Maunganui Road Traffic Calming Road Safety Audit - Golf Road to Hinau Street

Prepared for Tauranga City Council

Prepared by Beca Limited

19 December 2018

Figure 3: Change in approach lanes to roundabout

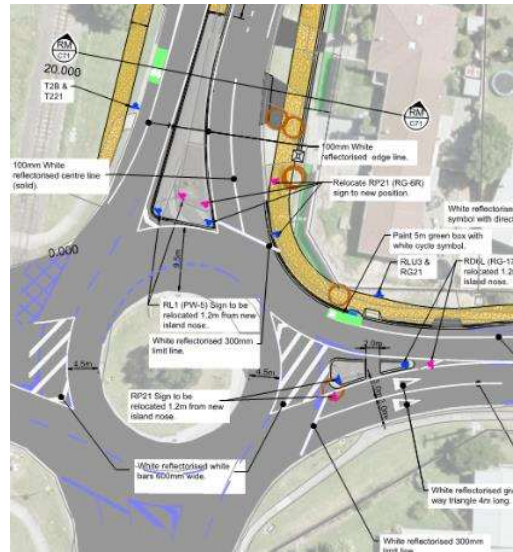
3.1 Changes to Roundabout Operation	Moderate
--	-----------------

The SAT noted that the changes to traffic movements within the Maunganui Road / Golf Road intersection will be largely facilitated by line marking. However, some approach lane movements & markings will appear the same to drivers as they approach. As this proposal includes restricting some to left turn only, this has the potential to result in drivers making late lane changes or simply driving over the new line marking. This is shown below by the proposed hatching area.

The identified risk here is when drivers expect others to follow the new line marking (i.e. turn left) and enter the roundabout only to collide with a vehicle that continues straight.

Designers Comment: The designer agrees with the SAT team; the design has since been updated to address these issues. See attached drawing Pavement Markings and Signs Layout – Sheet C70 Rev B.

Safety Engineer: Accept the changes that have been made, as per Designer Comment

Figure 6: Change required to approach lane markings

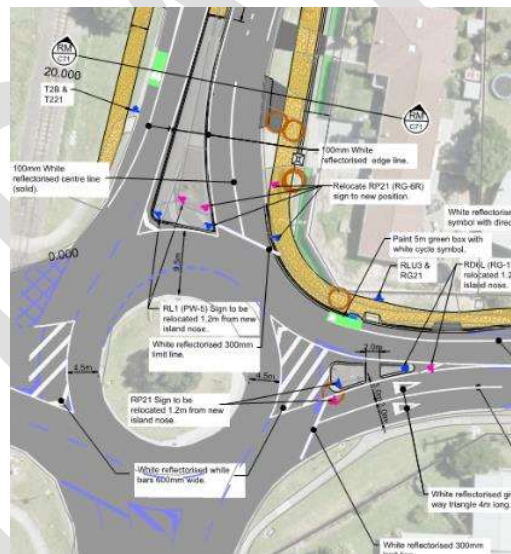
3.4 Arrow Markings for Revised Intersection

Arrow markings shown on both approaches to Maunganui Road need to be provided/corrected as they are a change over the existing and the line marking plans provided do not reflect this.

Designers Comment: The designer agrees with the SAT team; the design has since been updated to address these issues. See attached drawing Pavement Markings and Signs Layout – Sheet C70 Rev B.

Safety Engineer: Accept the changes that have been made, as per Designer Comment

Figure 7: Example of more favourable cycle drop kerb

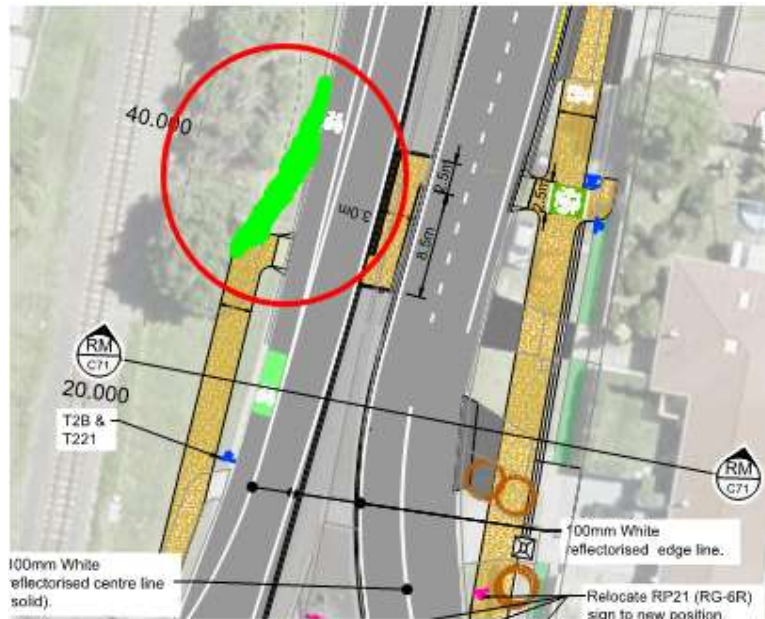
3.7 Cyclist Drop Kerb on Maunganui Road Northbound Minor

The SAT noted that any cyclist on the Hewlett’s Road shared path wanting to use the northbound cycle lane or Maunganui Road, need to use the proposed drop kerb. This is likely to be an awkward angle causing a slow movement speed for cyclists. A cyclist that is wanting to do this could surprise drivers, causing sudden reactions.

Provide a more suitable drop-kerb connection for cyclists connecting from the Hewletts Road shared path.

Designers Comment: The designer agrees with the SAT recommendations, this will be discussed with TCC.

Client Decision: Agree with Safety Engineer comment and modify connection.

Figure 9: Shared Path to Exclusive Path

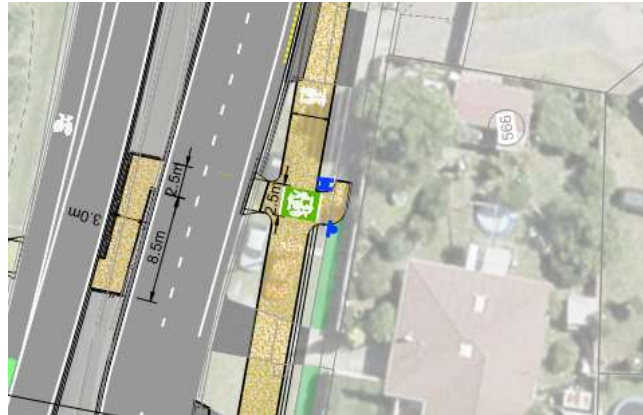
3.11 Shared Path Split Environment Change

The SAT felt that where the shared path transitions into the cycle only path section, there is no specific change in environment that would guide users into the appropriate location. This is likely to result in more pedestrians using the cycle path and conflicting with cycle users.

Designers Comment: The designer agrees, and we recommend that the dedicated cycle route sign be relocated in advance of the conflict point at approx. CH60

Safety Engineer: Agree with more detail required around the transition points. This needs to be consistent with other treatments in the network, and will be discussed with the Tauranga Cycle Planning team.

Figure 10: Give-way sign at path crossing

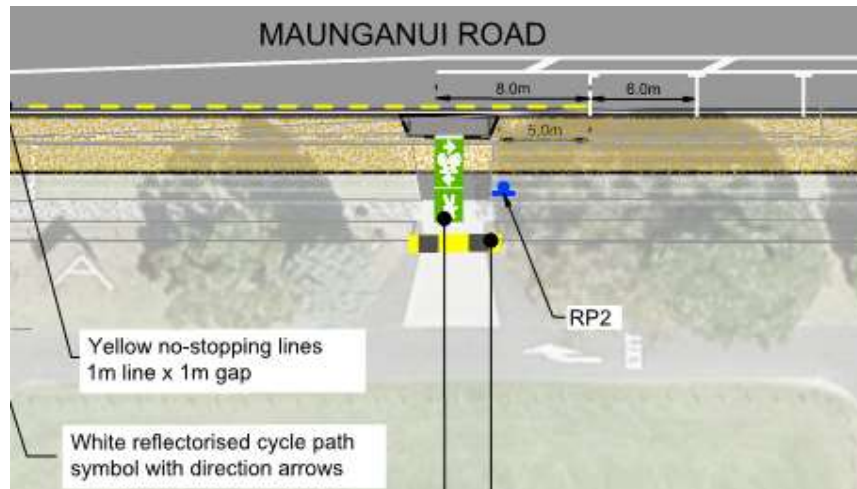
The RP-2 is shown at the school driveway to be located between the footpath and cycle path, may confuse drivers as to which path they give way to.

Designers Comment: The designer agrees that the RP2 signs should be placed between boundary and the footpath.

Safety Engineer: Agree with this change

Client Decision: Agree with the proposed change.

Figure 11: Cycle Path Through Bus Stop

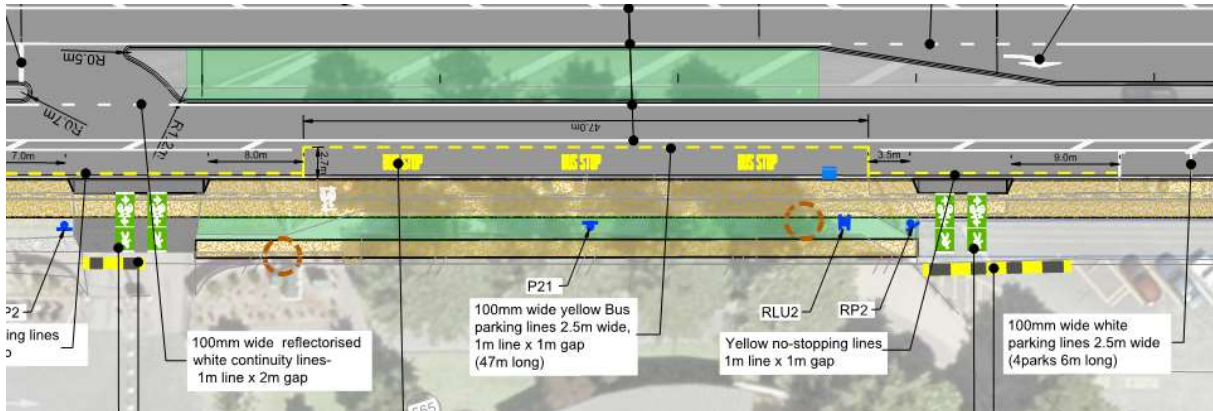
The cycle path is in direct conflict with the bus stop area, which is likely to be an area of significant conflict during school start/end times. School students are expected to be waiting on this path, increasing the likelihood of a collision and this is an area where pedestrians step off the bus straight into the path of cyclists.

Designers Comment: The designer agrees that this is a conflict area and further discussion with TCC to combine the cycle / footpath through this area is required.

Safety Engineer: Agree, detailed design needs to incorporate additional measures through the bus stop area, consistent with other treatments that have been provided through the TCC Cycle Plan.

Client Decision: Agree, provide consistent treatment as per advice from TCC Cycle Plan team.

Figure 12: Possible New Informal Parking Area

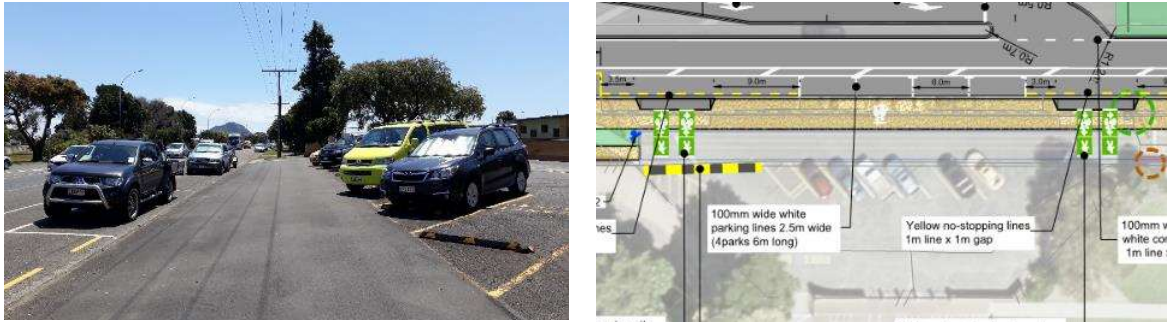
The provision of the widening for the cycle path section is shown to significantly increase the size of the drop off area in front of the school. The existing parking area appears to be able to spill over into the cycle lane section, which will be a notable conflict with path users.

Provide greater delineation of the cycle path through this location, and designate parking areas with additional measures (such as raised kerbing or bollards) to discourage parking in the cycle lane.

Designers Comment: The designer agrees and would propose installing a fence and move the position of the wheel stops further back. Consultation with the school will need to be held.

Safety Engineer: Agree, provide a pedestrian fence between parked cars and path, or other options, such as the use of planter boxes or other landscaping to soften the sealed expanse.

Figure 17: Proposed Cycle Crossing Point

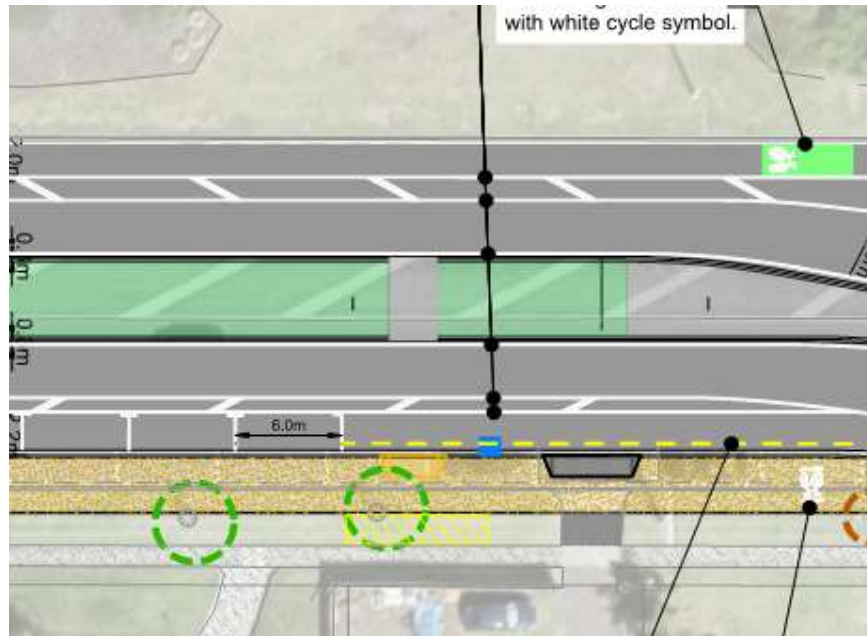
At the Tui Street intersection, the crossing does not provide a safe waiting location for those wanting to cross. A cyclist would need to wait in the cycle lane, potentially conflicting with other cyclists, or wait next to the traffic lane in an unprotected location.

Provide a safe waiting area for cyclists crossing at Tui Street (e.g. hook turn facility with hand rail).

Designers Comment: This cycle crossing point will be removed and will no longer be provided. A design investigation is currently underway to provide a gap in the physical island at this point for vehicles at the private properties to be able to gain access to the roundabout.

Figure 19: Delineation of Cycle Lane

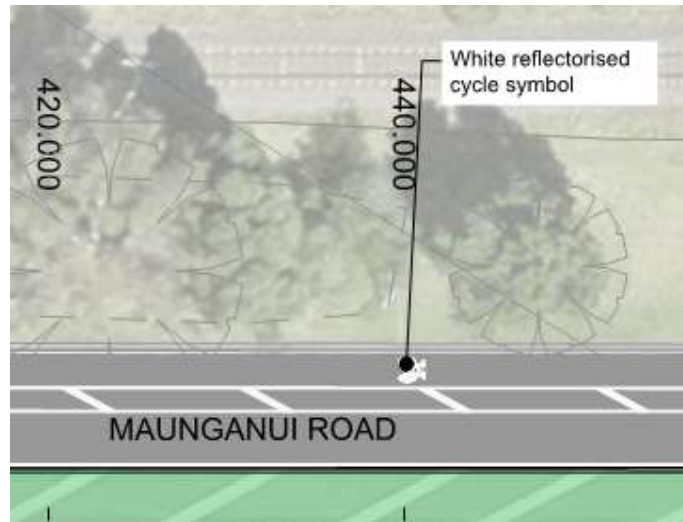
The cycle lane on the western side of Maunganui Road will need to be clearly delineated so that drivers are discouraged from driving within the lane and so cyclists are safe from errant vehicles. Physical protection is typically favourable for cyclists rather than just line marking.

Designers Comment: The designer considers physical protection to be a hazard to the cyclists. However safe hit posts could be considered.

Figure 20: Short Stacking Lanes Approaching Hull Road

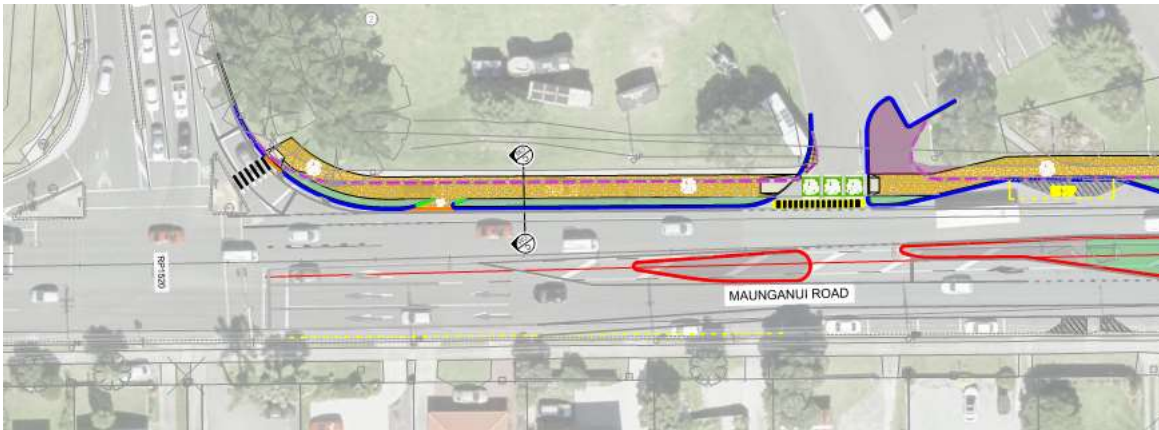
The provision of a new right turn facility into Blake Park and median will prevent informal stacking for the right turn lane into Hull Road. This will reduce the level of service for the approach and is could result in increased red-light running and late lane changes approaching the intersection.

Review traffic modelling to check there is sufficient stacking space for the right turn. Extend the two-lane approach to the intersection in necessary by removing some parking spaces to provide greater functionality.

Designers Comment: The designer agrees that this physical island should be removed to provide stacking for right turn movement into Hull Road and to provide a painted right turn median into Blake Park. Termination of the raised median to be discussed with TCC

Figure 21: Effective Path Widths

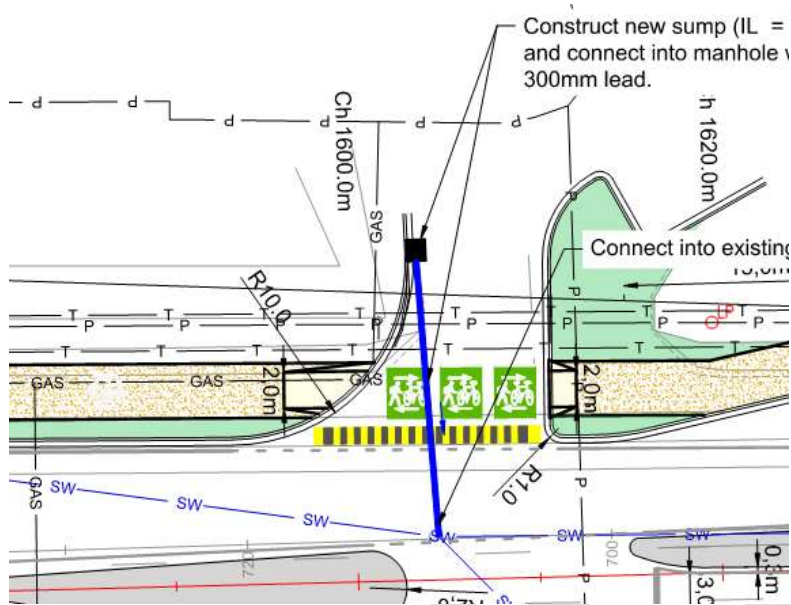
The SAT noted that crossing widths decrease to 2.0m wide in some locations. This is likely to have a significant impact on the ability for multiple users to cross at the same time and has the potential to funnel users together and create conflicts between cyclists and pedestrians in particular.

Designers Comment: The designer agrees, and the crossings will be widened to suite the path width.

Figure 23: Potential Conflict with Shared Path and Bus Stop

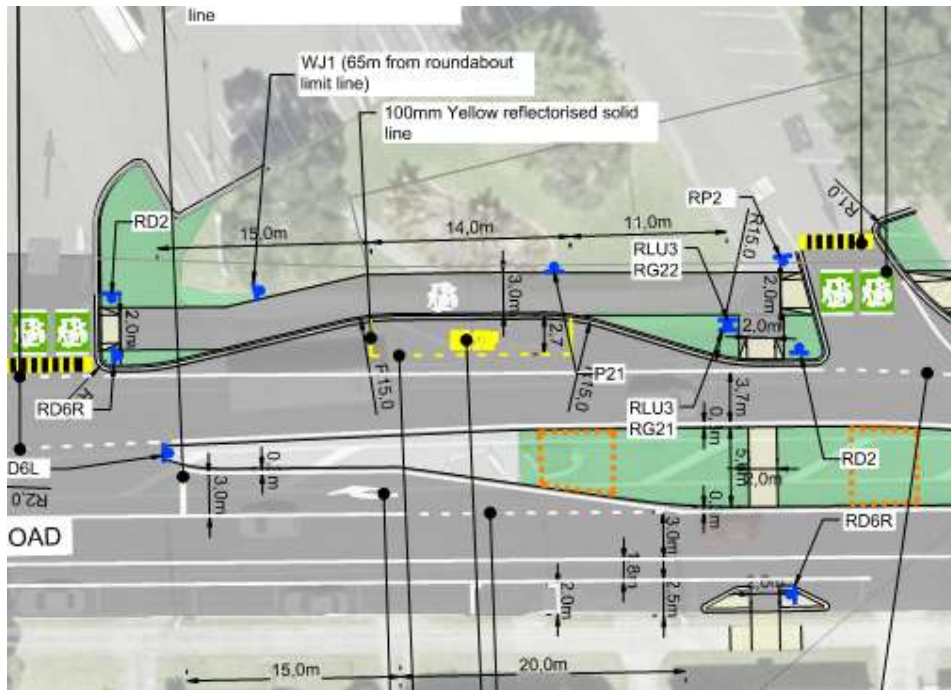
Similar to issue 3.13, the SAT were concerned with the shared path and bus stop waiting area sharing the same space, in particular cyclists as on-road cyclists will be discouraged with the lack of on-road facility. It is likely that this will increase the risk of a passenger alighting a bus in front of a cyclist on the path.

Designers Comment: The designer agrees that this is a conflict area and further discussion with TCC to address this conflict area is required. An option can be, the pavement colour can be changed and signs installed to alert cyclists passengers are dismounting.

Figure 25: Limited Roundabout Deflection at Roundabouts

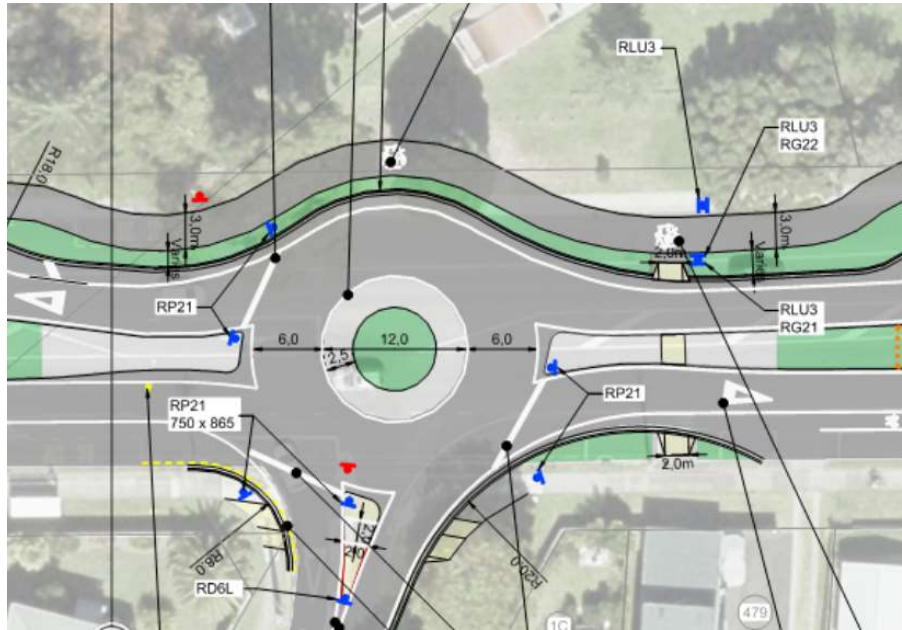
The SAT noted that the deflection at roundabouts in the southbound direction will not constrain vehicle speeds as effectively as the northbound direction, and at both intersections may offer very little deflection to drivers at all.

Designers Comment: The designer agrees with the recommendations, however the deflection angle at the exit to the roundabout is achieved when considering the position of the edge line, the location of the kerb is however governed by the turning movement of the design vehicle.

Figure 26: Continuation of Opposite Edgeline

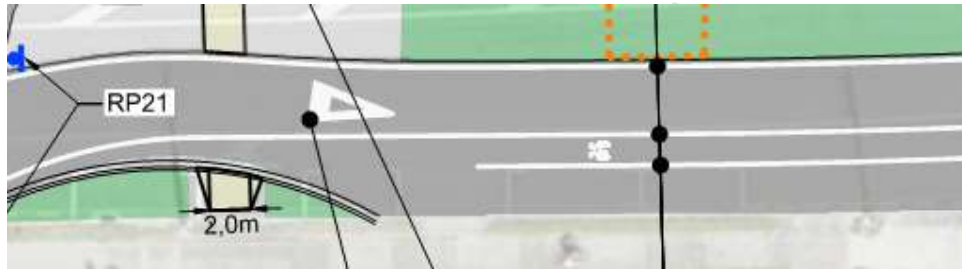
4.8 Termination of Cycle Lane Approaching Roundabout **Minor**

At the end of cycle lanes, the right-hand edge line continues, rather than the left, which will result in cyclists having to cross the edge line to re-join the traffic lane.

Designers Comment: *The designer agrees with the SAT recommendation and the edge line will be amended.*

Safety Engineer: *Agree with SAT and Designer response*

Figure 27: Drop Kerb for Disabled Space

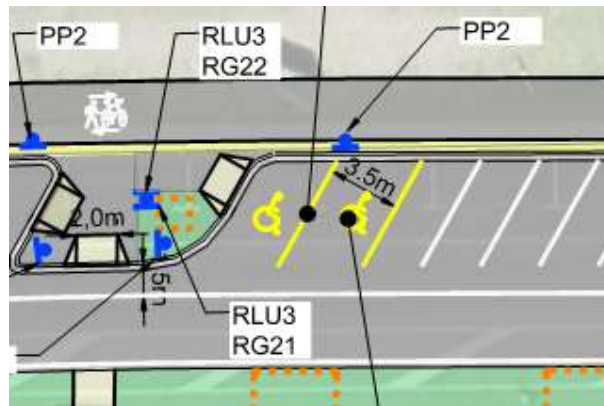
4.9 Disabled Parking Ramp to Kerb **Minor**

With disabled parking provided at the end of each parking bay, a section is proposed where there are two disabled spaces side by side. If a vehicle is in the park closest to the ramp, this may not be able to be used by the second disabled user. This could result in a disabled user trying to find other locations to get onto the path, possibly entering the traffic lane at times.

Relocate the second disabled space to another drop kerb location or provide some drop kerbing in front of parking spaces to help cater for this space.

Designers Comment: The designer agrees and the parking bay will either be relocated or sufficient disability access will be provided at this location.

Safety Engineer: Agree with SAT and Designer response, review provision of mobility parking and ensure they comply with required standards.

Figure 28: Totara Street Approach to Maunganui Road

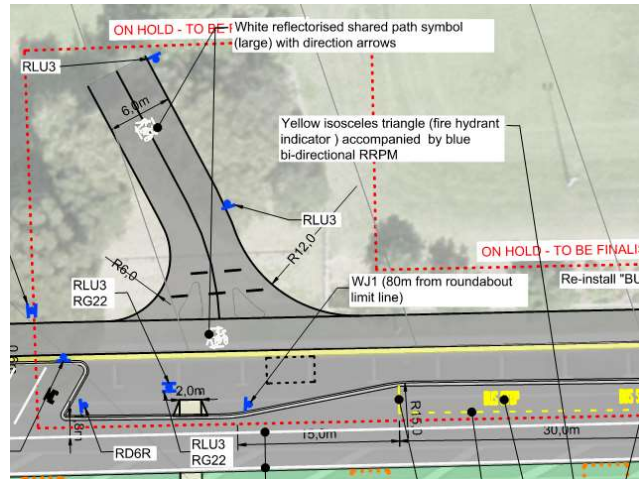
At the connection with the Totara Street Cycleway, the SAT felt that this will need to be managed appropriately to ensure that users are aware of this intersection and slow accordingly. The risk is from cyclists missing the intersection and entering the road or colliding with other users on the path that are travelling along Maunganui Road. (appreciating the notation of hold status).

Implement the appropriate signage (such as give way markings and signage) and potential cycle calming measures to manage user speeds and provide an indication to users of the approaching intersection.

Designers Comment: The designer agrees and since the SA the design has been updated and U-Rail terminals have been introduced at this access point. The terminals have been placed to provide a chicane effect to eliminate access speed at this conflict point. The u-rails will also be installed in sleeve sockets to ensure easy removal to allow access for emergency vehicles.

Figure 29: Door Zone Conflict with Cycle Lane

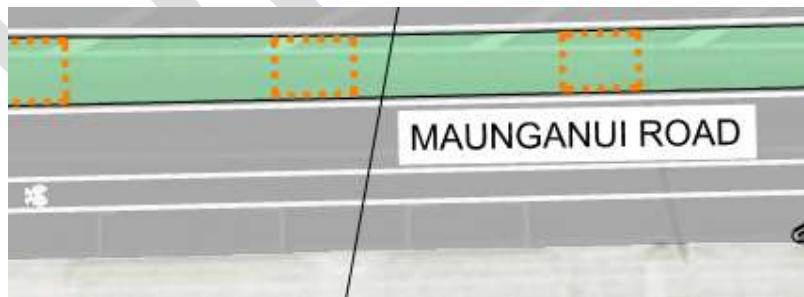
The plans do not appear to show any door zone protection for southbound on-road cyclists adjacent to parallel parking. This would lead to car doors opening in front of cyclists leading to collisions.

Provide door zones to protect on-road cyclists.

Designers Comment: The designer agrees with the SAT recommendations. This option was however investigated during the design process and would trigger the elimination of the parking areas or narrowing the raised central median. TCC to make final decision.
